Further information from Graeme Sawyer relating to my previous evidence.

In May 2022 the Department added a Regulatory statement to their website in an apparent attempt to explain their perspective. Titled Regulatory Statement: Monitoring of Electrical Conductivity in the Beetaloo Sub-basin.

Figure 1 - Sensor fouling research data plot from salinity research.

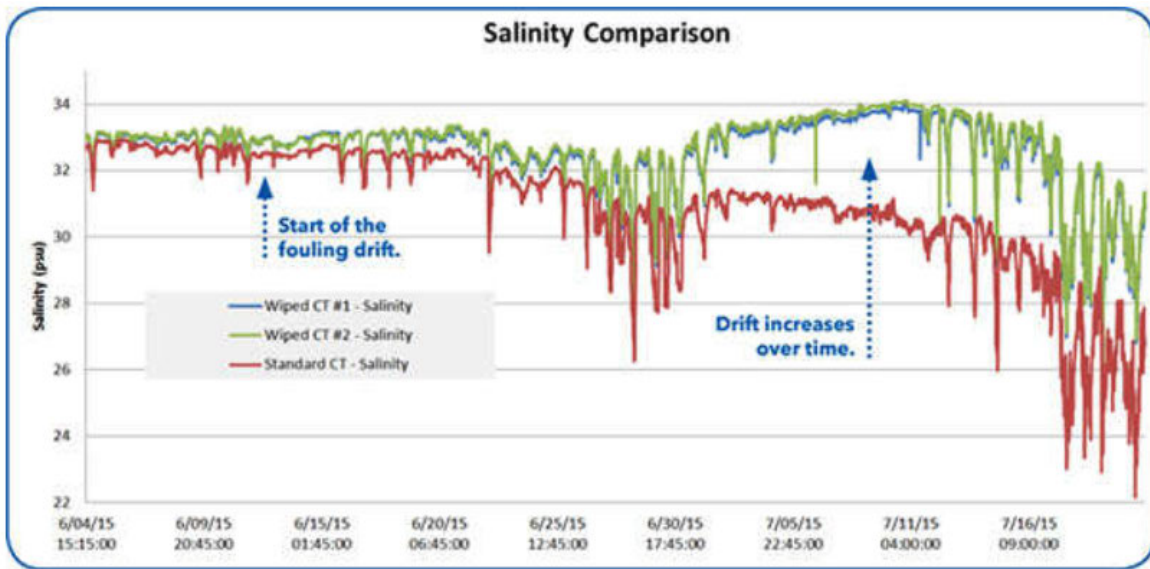
1 Sensors using an electrical current to measure micro siemens as a salinity or dissolved ions measurement typically show reduced readings when they suffer from fouling not sudden increases⁵.

2 Even when they are suffering from fouling the sensor will still show the up and down movement changes in salinity readings as can be seen from the image below where the red line, the fouling sensor plot, is still showing the peaks and troughs in synch with the green and blue plots from the self-cleaning sensors. This is clear in Figure 1 below. The 28 August 2019 EC spike looks more likely to be real when this evidence is considered.

Figure 2 Data inconsistency plot from NTG Regulatory Statement- Electrical Conductivity

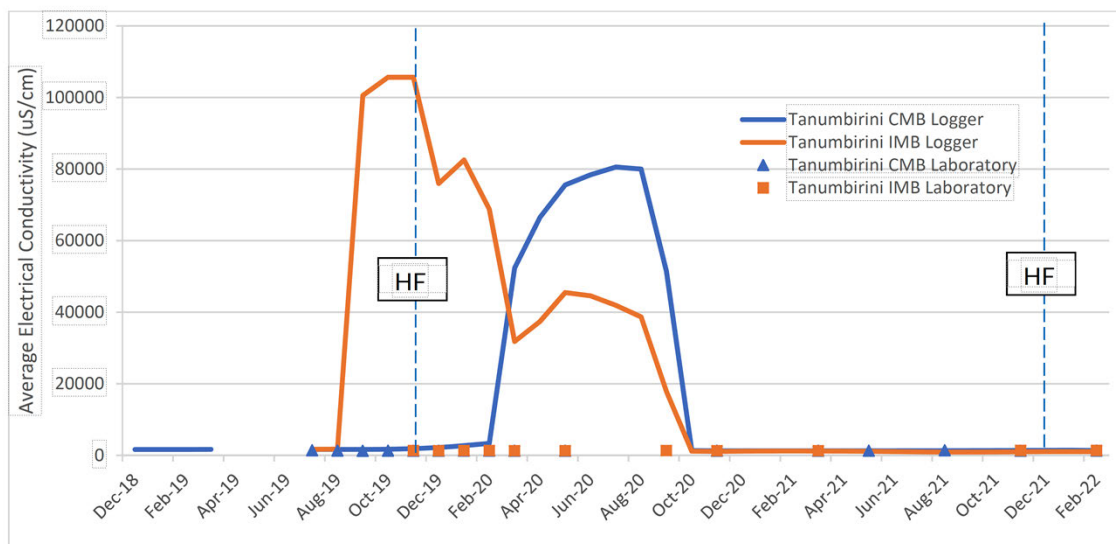
There is a clear and unexplained discrepancy with the manual data, which has been collected in a different manner. The regulator needs to take control of this process and use independent sources for this work to meet transparency requirements and use multiple sensors as specified to develop a clear understanding of these issues relating to the water column and bores. This must be transparent. There is no manual data from RN040936 in the period leading up to the EC reading spike in Aug 2019 that I am aware of. It is strange that this graph shows no manual data (Blue triangles) from RN040930 at the time of the EC spike in that bore's data. This needs investigation.

This idea that the data from the Control bore RN040930 refutes the data from RN040936 is not supportable. The Control bore RN040930 was specifically designed and located “upstream” so as to not be influenced by the wells. So why is it claimed this data refutes the sensor data?

Figure 3 Water elevation data RN040936

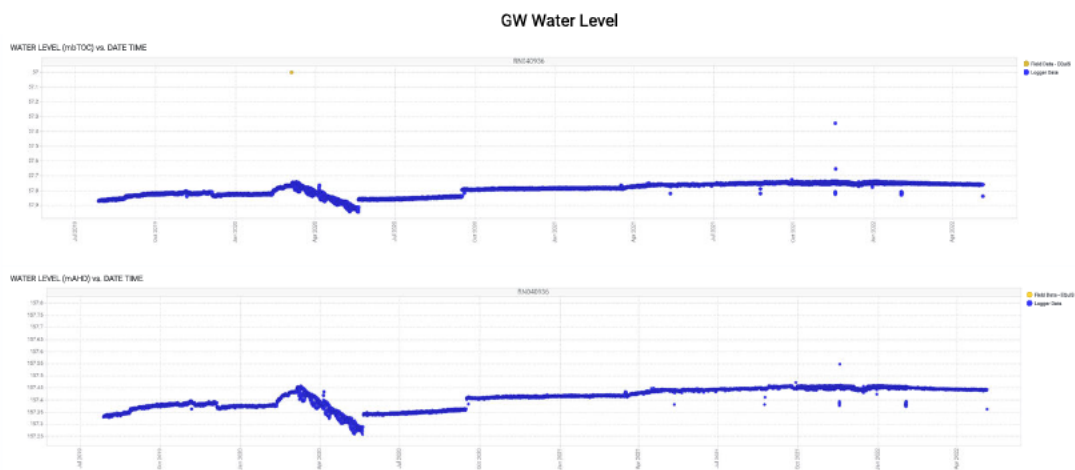
Further there are concerns with other water elevation data that appears to roughly coincide with the salinity spikes in the bores. Figure 3 below shows a major change in the water elevation around the time the spike in RN040930 occurred. This indicates that there was fracking activity at the time of salinity spikes suggesting that the vibrations of operation at one well on a pad could be impacting the bonding on nearby wells perhaps calling into question the multi well wellpad concept. I do not have access to the Well Operations management plan WOMP to analyze this and would ask the senate inquiry to facilitate this.

Figure 1 - Daily Average EC plot ($\mu\text{S}/\text{cm}$) from IMB RN040936 around the time of the initial increase in EC

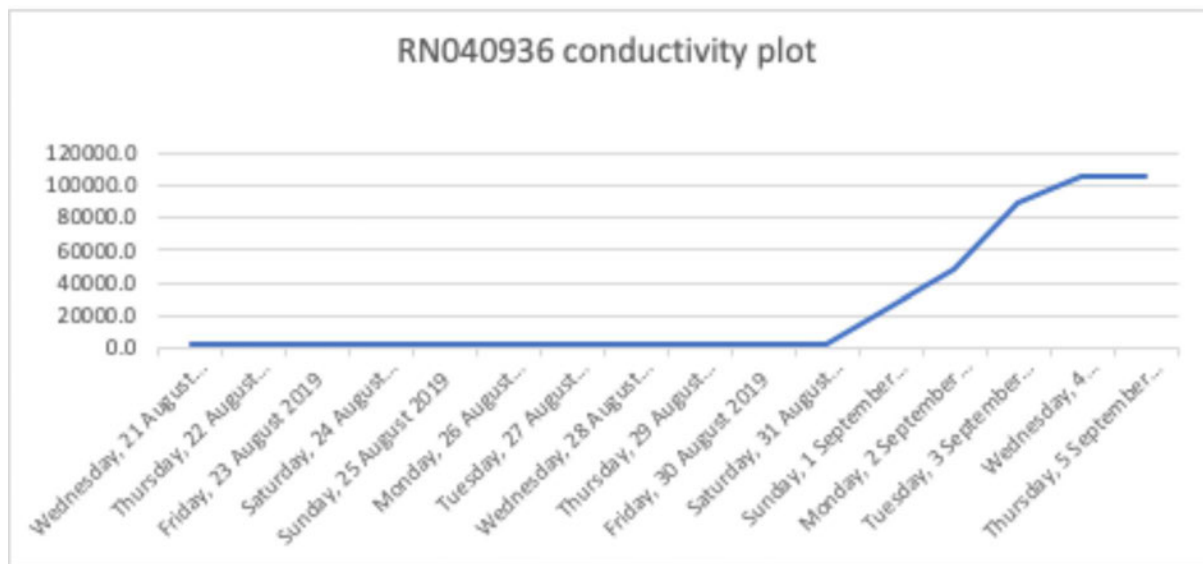
The raw data from RN090936, also known as the impact monitoring bore, reveals an approximately 50-fold increase change in the conductivity reading microsiemens/cm ($\mu\text{S}/\text{cm}$) which is a standard measure of total dissolved ion load/salinity in water, commonly used to track the salinity of freshwater.

The conductivity $\mu\text{S}/\text{cm}$ measurements began in bore RN 040936 on the 27th July 2018 with a value of 1714.8 $\mu\text{S}/\text{cm}$. For the next 13 months, until Thursday 27th August 2019 EC readings were between 1670 $\mu\text{S}/\text{cm}$ and 1730 $\mu\text{S}/\text{cm}$.

The raw data shows that the conductivity measure went above 1800 ($\mu\text{S}/\text{cm}$) for the first time on Thursday 29th August with the early morning (0:00 hrs) reading of 1804.1 $\mu\text{S}/\text{cm}$. By that evening the reading was 1861.9 $\mu\text{S}/\text{cm}$. By Friday night, the reading was 2027.1 $\mu\text{S}/\text{cm}$, by Saturday night 5895 $\mu\text{S}/\text{cm}$, By Sunday night 34,473.8 $\mu\text{S}/\text{cm}$. By Monday night the reading was 62092.6 $\mu\text{S}/\text{cm}$ and by Tuesday night it had reached 105651 $\mu\text{S}/\text{cm}$ which is around the maximum the sensor was able to measure.
